New CTP Replacement Parts for Caterpillar® Equipment

CTP GLOW PLUGS

NEW IMPROVED

Part No.	Description
3H2033	GLOW PLUGS
3T8706	GLOW PLUGS
3T9562	GLOW PLUGS

Cross Section

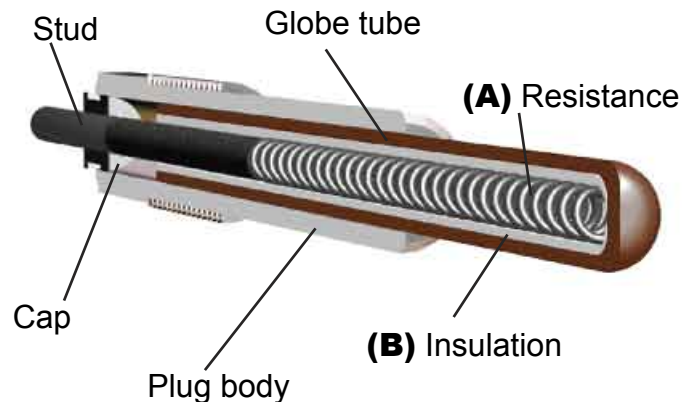
Tube Alloy: offers a higher resistance to the erosion produced into the combustion chamber.

Implementation of a better system of welding between the electrical resistance and the tube : offers a more homogeneous and controllable weld, which avoids the resistive wire's weakness during the welding process.

Internal resistance's re-design and material change (A): produces a higher durability, and the supporting of unexpected over-tensions.

The addition of an internal insulating

material between the resistance and the tube (B): provides a better insulation control, with a lower internal humidity retention, generating a longer life for heater element
